3 Volt Intel[®] Advanced+ Boot Block Flash Memory

28F800C3, 28F160C3, 28F320C3, 28F640C3

Specification Update

Order Number: 297938-014

2. 28F320C3xC Reset Failure

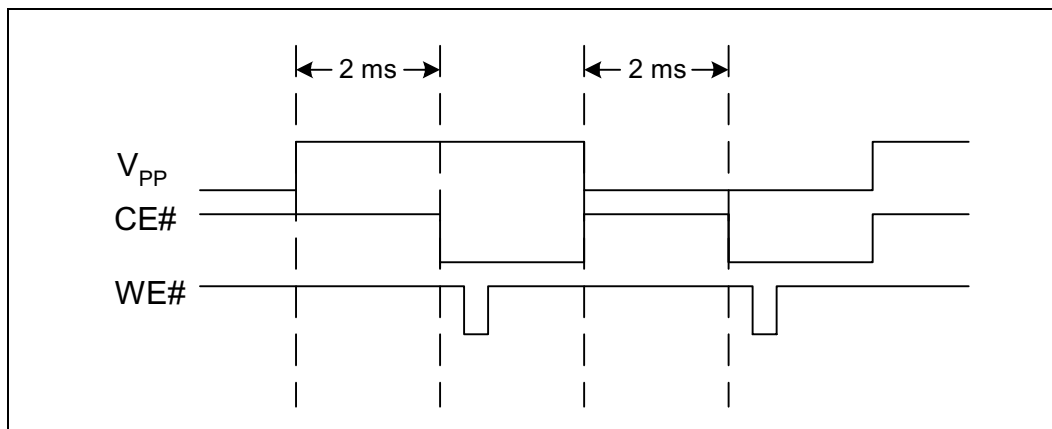
Problem: The 0.18 μm 28F320C3xC devices can unintentionally reset under certain conditions where V_{pp} toggles.

Implication: When the reset occurs, any command being executed is interrupted and the flash switches to read array mode.

Workaround: There are four workarounds for this erratum:

- 1) Tie V_{pp} to V_{CC} ;
- 2) If the third and forth digits on the top side FPO mark (third line) is equal or greater than “23”, then V_{CC} may be set from 2.7v to 3.3v. V_{CC} must not exceed 3.3v
- 3) Set V_{pp} to a static high or static low level as shown here; and

4) Wait 2 ms after a V_{PP} transition to access the flash device, as shown here.

Figure 1. Workaround Placement

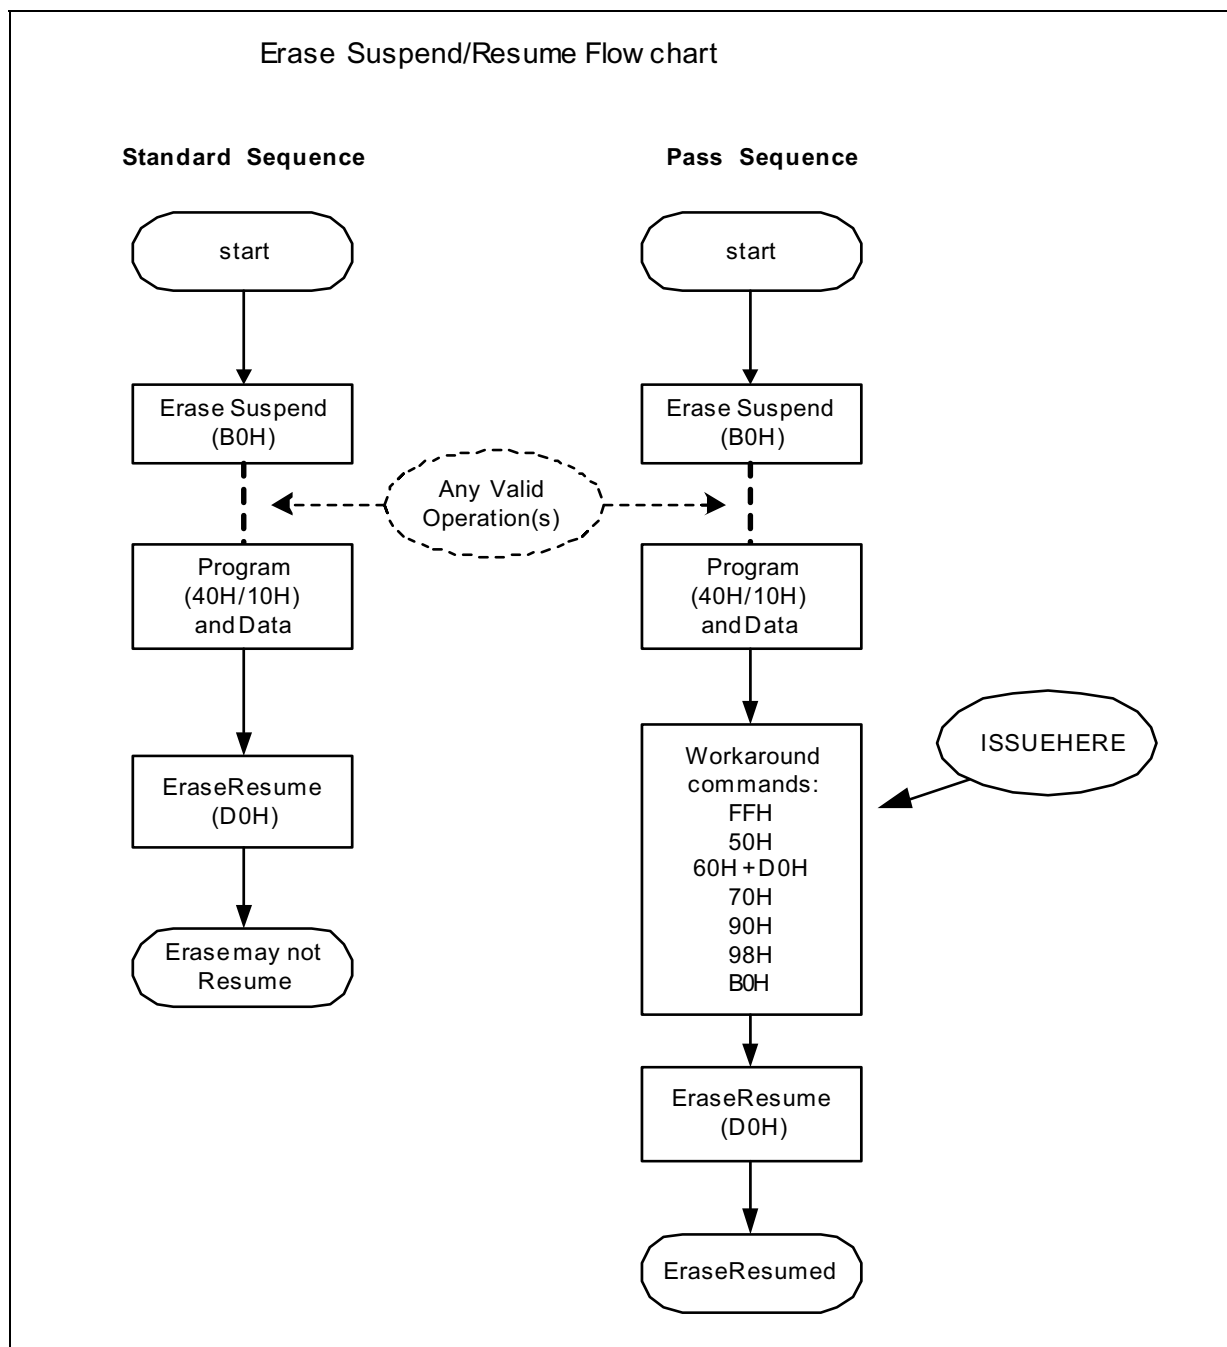
Problem: On the 0.18μm 28F160C3xC devices, a design anomaly was discovered. During an Erase-Suspend operation, if the Program (40H/10H) sequence is executed, under limited conditions the proceeding Erase Resume command (D0H) may not actually resume the device. No customers have reported failures in product applications. Customers who use any version of FDI (Intel Flash Data Integrator) software will not see this issue. If the Read Array command is issued prior to the Erase Resume command, users will not see the issue (typical in XIP applications).

Implication: The Resume Command (D0H) may be ignored by the device and will not correctly resume. The device will appear to remain in suspend (via status register). After a reset of the flash device the status register will clear. This failure has been recreated in a lab environment only.

1. If FDI (Intel Flash Data Integrator) software is used, users will not see the issue.
2. During an Erase-Suspend (B0H), user must issue any of the following commands after issuing the Program (40H/10H) and data sequence but before issuing the Erase-Resume (D0H) command.

5. 28F160C3xC and 28F640C3xC Lock/Unlock/Lock-Down Operation

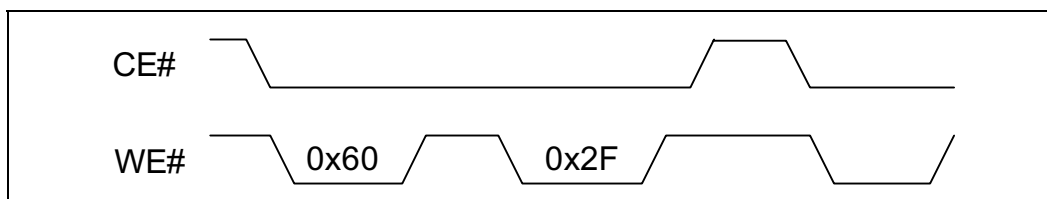
Problem: On the 16Mb and 64Mb 0.18µm devices, if CE# is deasserted after any block lock operation and before the next write sequence, the part may perform the same operation on additional blocks. (See waveform below.)

Implication: When CE# is deasserted after performing a block lock operation to a specific block and prior to the next write sequence, other blocks may perform the same operation.

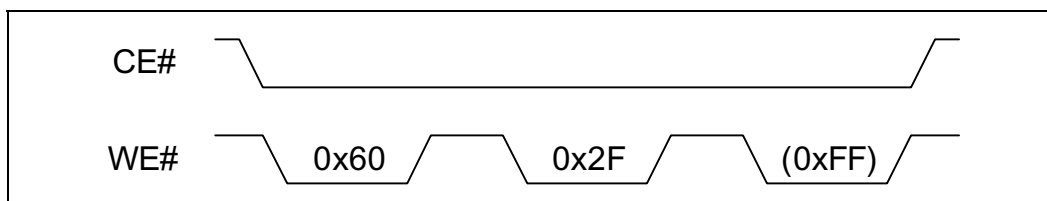
Workaround: Depending on software implementation, systems may already be effectively managing this erratum. There is currently a workaround for this erratum:

Immediately after performing a block lock, unlock, or lock-down operation, perform a valid write sequence before chip enable (CE#) is deasserted.

- 1) Assert CE# and toggle WE# to write the block lock setup command (0x60).
- 2) Toggle WE# a second time to write the confirm command (lock = 0x01; unlock = 0xD0; lock-down = 0x2F).
- 3) Toggle WE# a third time (ex: 0xFF- Read Array) before CE# is deasserted. (See waveform below.) Any other valid write sequence will also work (i.e., 0x90 - Read Configuration, 0x40 - Program, 0x20 - Erase).
